MILITARY SPECIFICATION-

MICROCIRCUIT, DIGITAL, TTL,

NAND BUFFER, MONOLITHIC

This amendment forms a part of Military Specification MIL-M-0038510/3E(USAF), dated 1 December 1975.

Device types 02 and 03

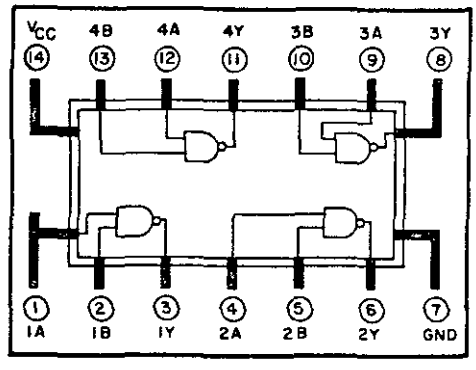
FIGURE 1, Device type 02 and 03, delete and substitute:
